Work Order ID 66501

Item ID: D4095-041 Accept  Setup Start 
Revision ID: Stop 
Item Name: Wearplate Assembly
Start Date: 2/17/2011 Start Qty: 4.00  Cust Item ID:
Required Date: 2/24/2011 Req'd Qty: 4.00  Customer:
Reference:

DRAWING NO. D4095
REV. A
SHEET 1 OF 4
TITLE WEARPLATE
SCALE NTS

| DE APPR. | | ALTERNATE WEARPLATE KIT | NTS |

**FIGURE 1: CHANGE AT FORWARD SADDLE LOCATION
WITH DSI-9517-011 KIT INSTALLED**

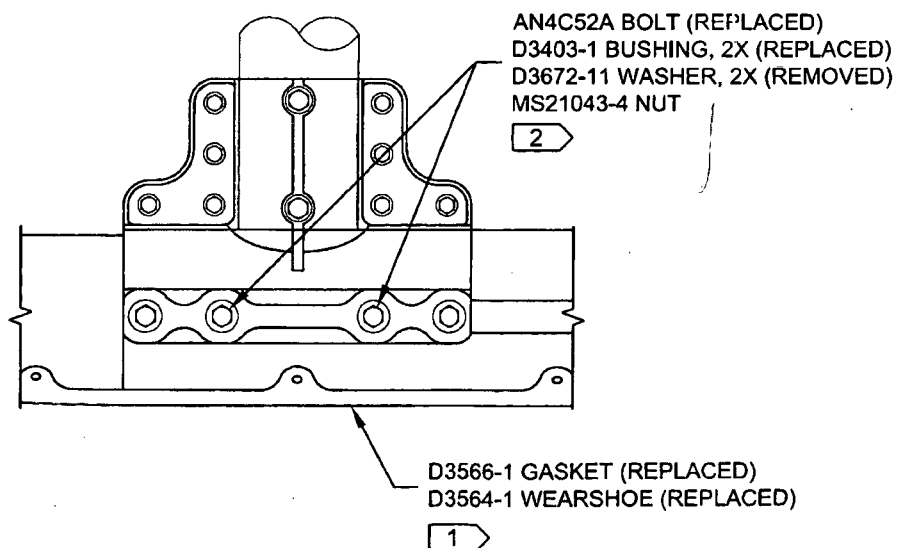
5. Locate the DSI-9517-011 Wearplate Kit as shown in Figure 1 and 2 of this service instruction.
6. Transfer drill qty.(2) Ø0.438 hole from the skidtube/saddle to the D4095-041/-043 Wearplates Assemblies. Deburr. Touch up finish per Item 5.2.14 of ICA-D412-742 as required.

Ian is preparing the DSI 9517 alternate wearplate kits by transfer drilling the holes from the mid tube to the wearplates and he is having slight alignment issues. This is mostly due to going Plus One Rockguard on the wearplates (neoprene gasket was being compressed against the saddle and now the harder material is not allowing for that). Ian has oversized the Ø0.438 transfer drilled holes to Ø0.500 to compensate on the first wearplate. Is it acceptable to upsize the hole on all of them?

As discussed, I'm not a big fan of the sloppy fit as I think this will allow the wearplate to rotate around the skidtube in service and create a similar problem to what we already had. So, I'm OK with the wearplate you've already made to 0.50", but I would leave the remaining holes at 0.44". If the customer struggles to get it on at 0.44", then we can allow him to open up to 0.50" in the field.
